Project Name: Village At Mill Pond - Master Plan Design Criteria Amendments

Project Description: Amendments to the Design Criteria for the Village At Mill Pond - Master Plan.
See attachment for proposed amendments.

The Village At Mill Pond Design Guidelines - Explanations

WINDOW TRIM:

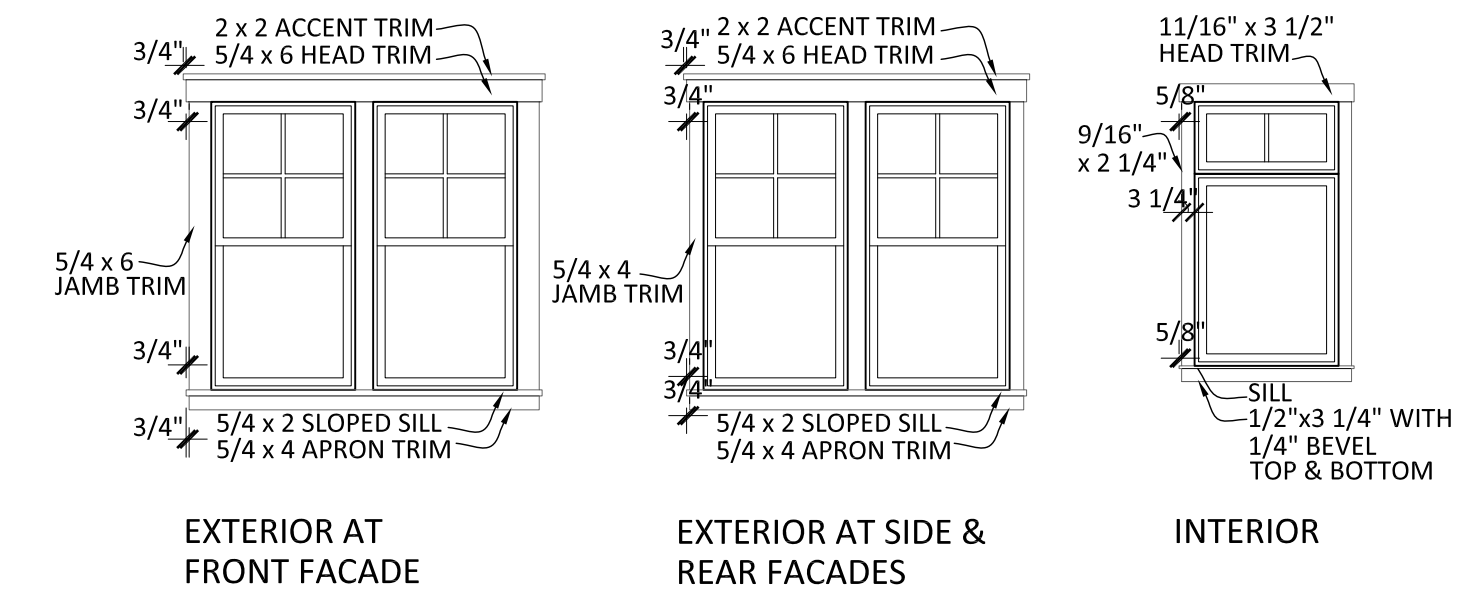
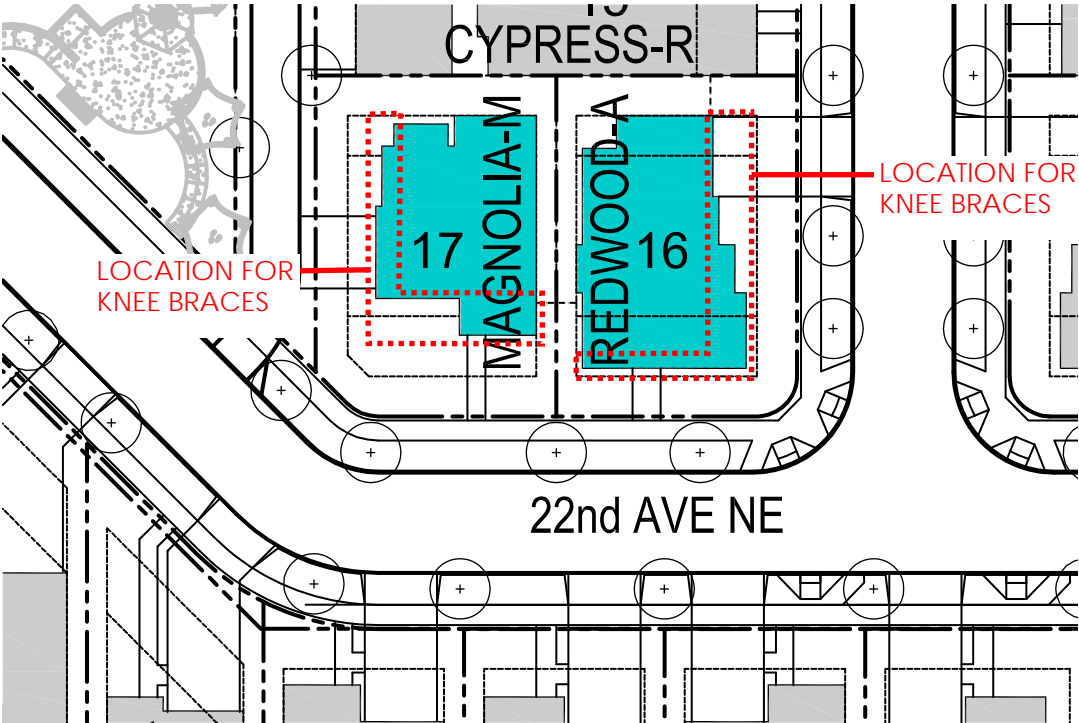
- Removal of unclear sentence. This implies all models to get bay window. Windows will be trimmed out on all four sides and installed in plane with wall.
- See attachment 12-A Window Trim for example of how this criteria is addressed in existing site.

FEATURE LOCATIONS ON CORNER LOTS

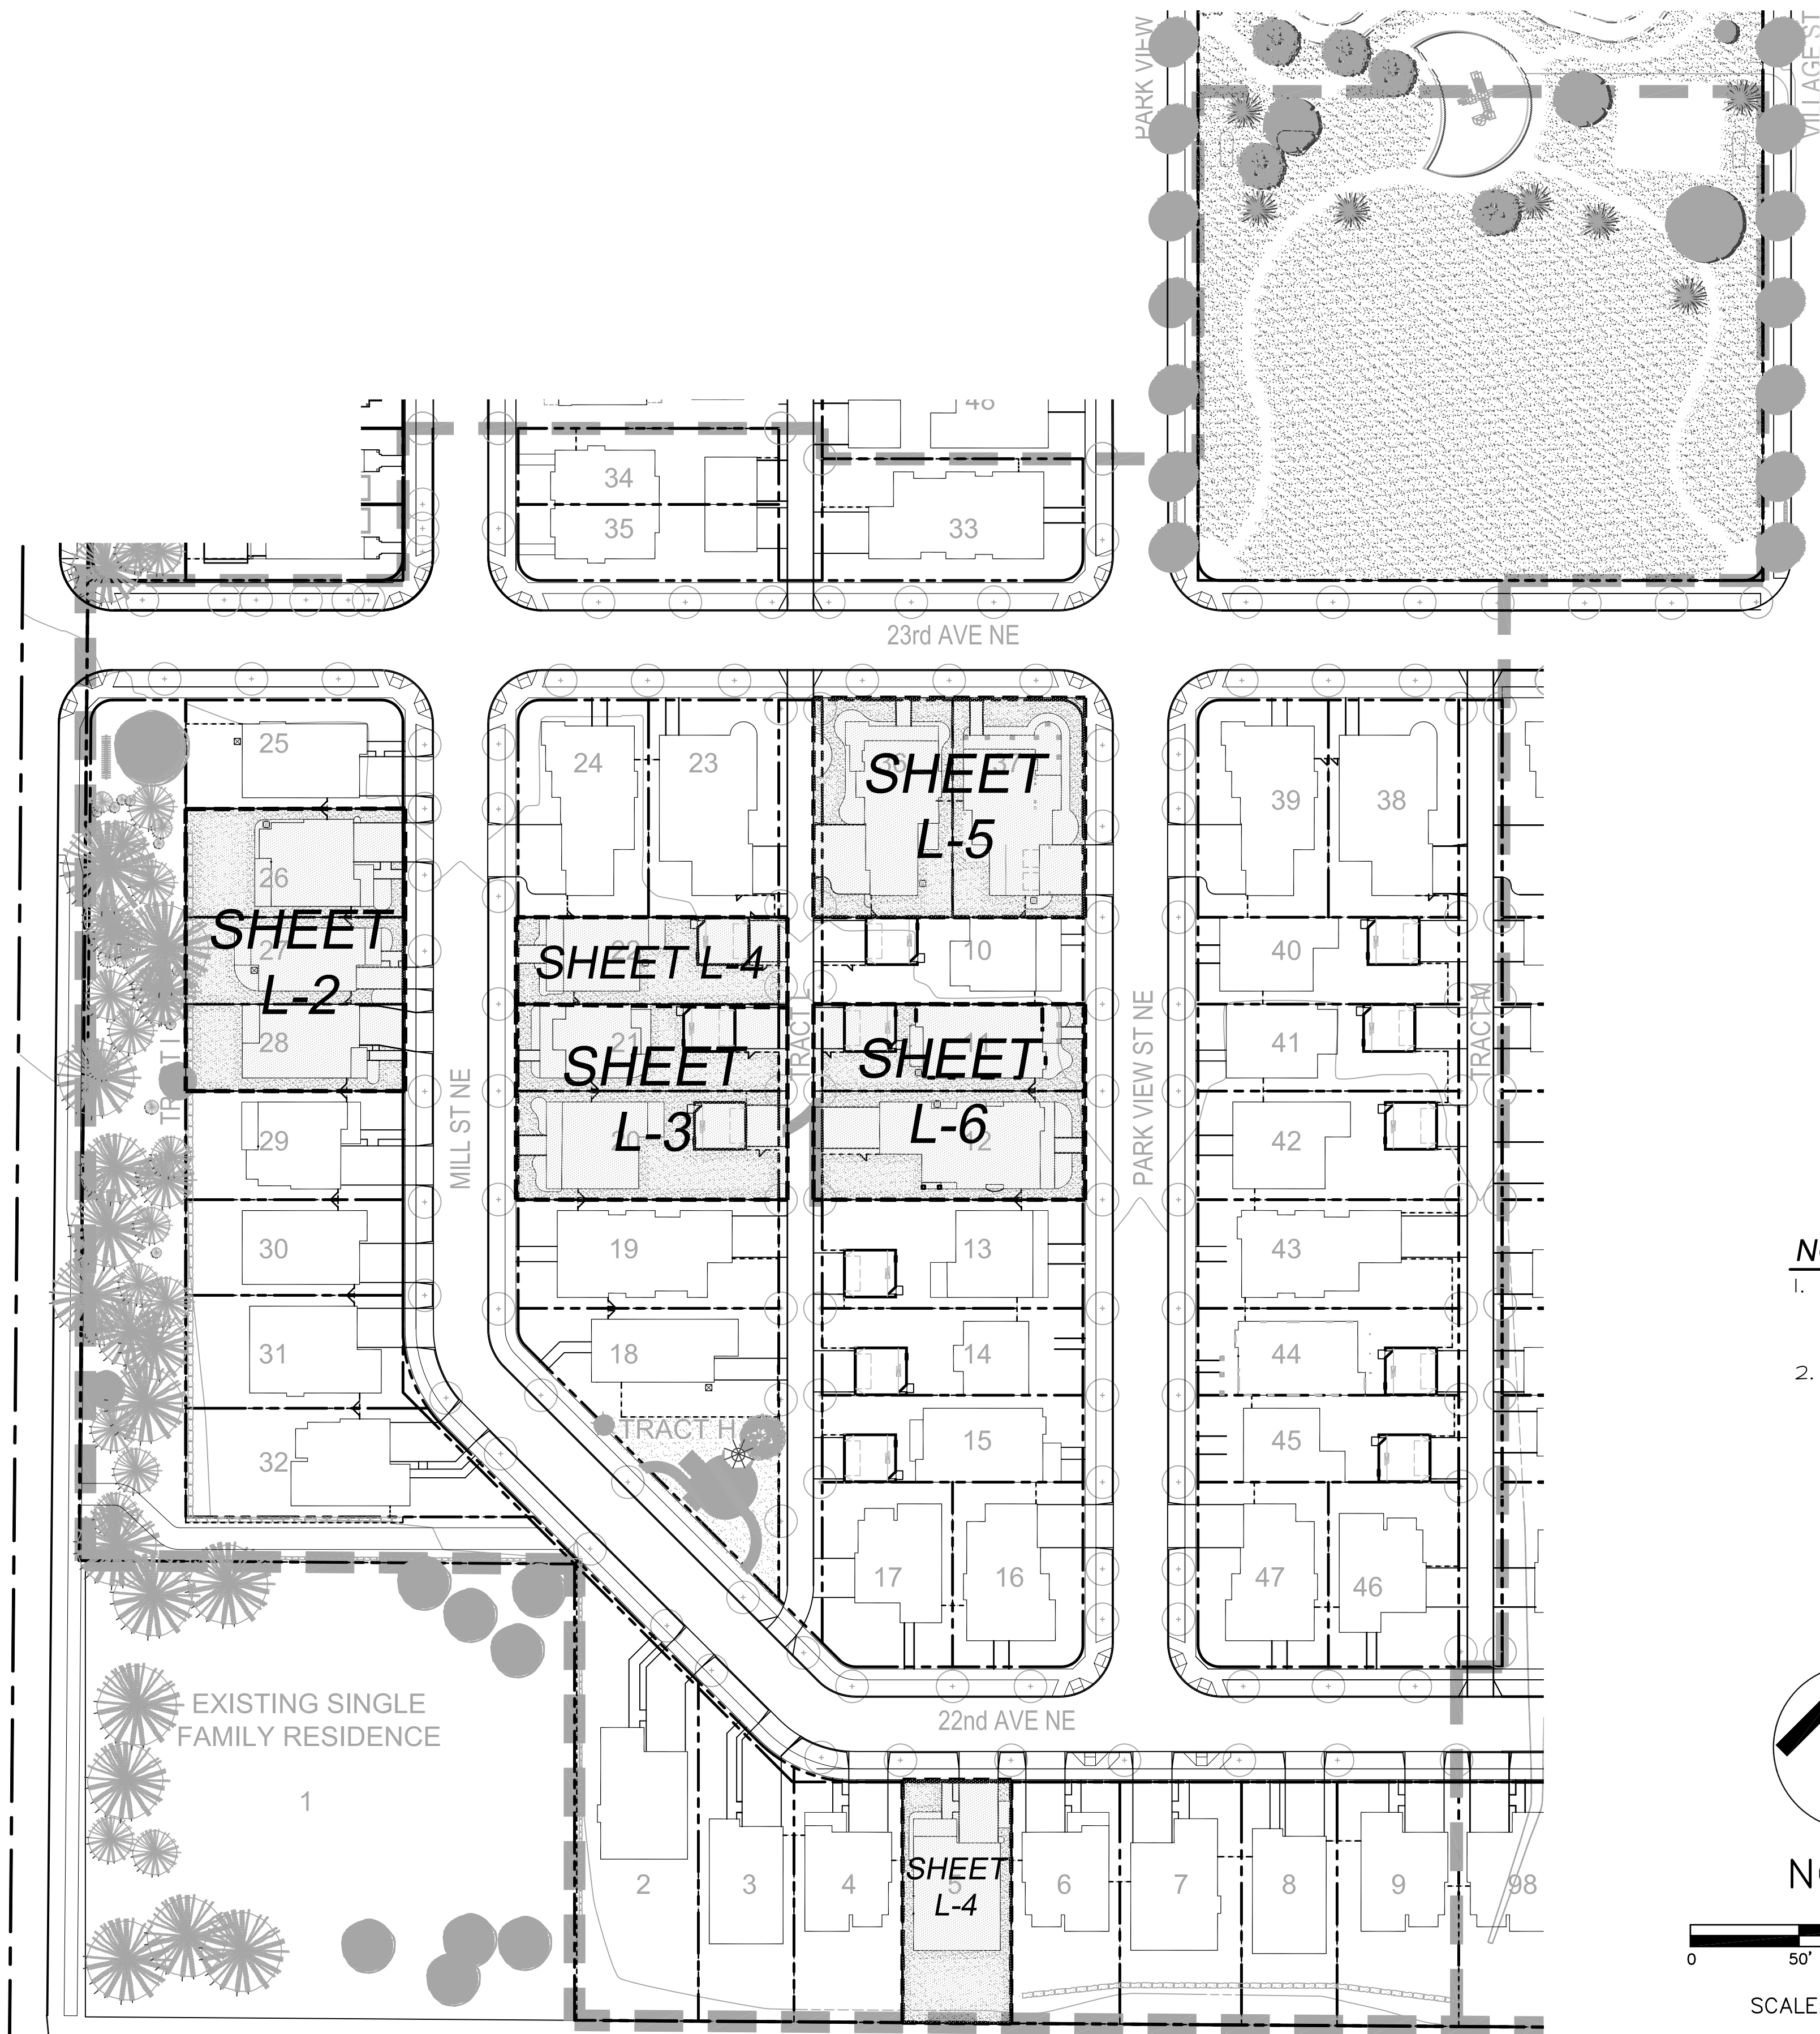
- Clarifying extent of architectural detail does not extend to sides or back of house, which have little to no visibility from the street. This addition to the criteria still achieves the cohesive 'feel' of the development and meets the intent.
- Houses on corner lots or adjacent to public open spaces would still need to meet this requirement.
